CITY COPY
16350 MIDWAY RD

PROPOSED FACILITY FOR:
BAS REALTY
LIMITED PARTNERSHIP

4-20-95

SITE PLAN - PART "BB"
GRADING & DRAINAGE

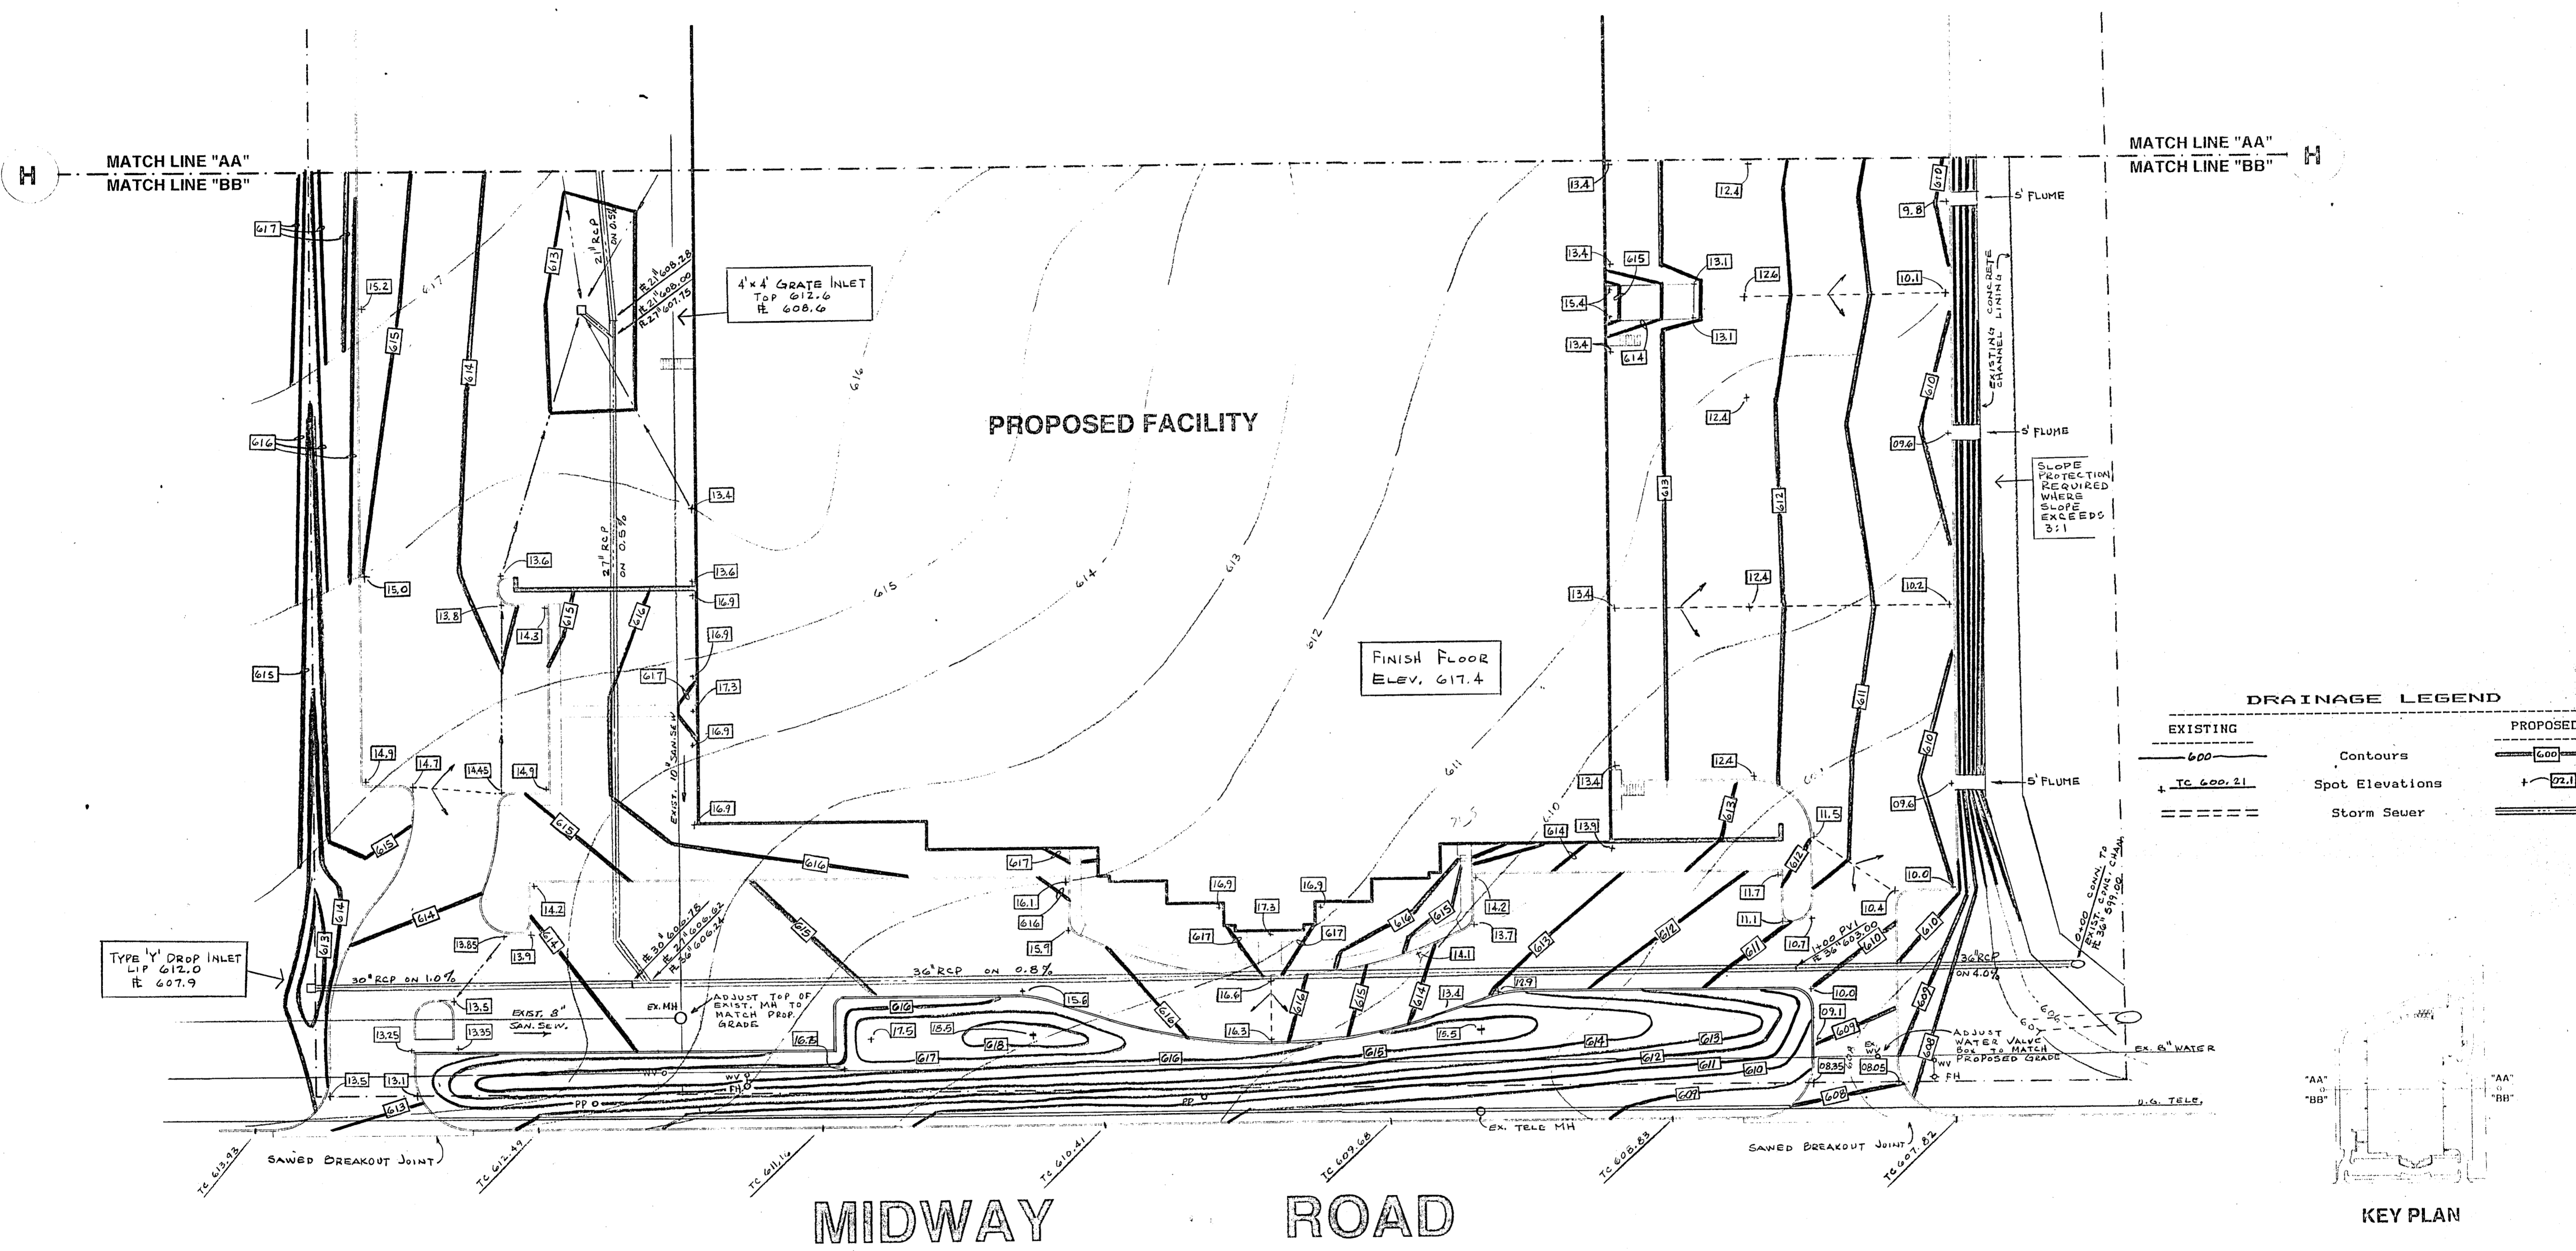
NOTE: CONTRACTOR SHALL PROVIDE EROSION CONTROL SILT FENCING THROUGH-OUT DURATION OF CONST. ALONG ENTIRE LENGTH OF R.O.W. @ MIDWAY RD, ENTIRE LENGTH OF DRAINAGE CHANNEL (SOUTH PROPERTY LINE & AROUND ALL EXISTING & PROPOSED DRAINAGE INLETS).

All areas disturbed by construction shall be revegetated
 JRB
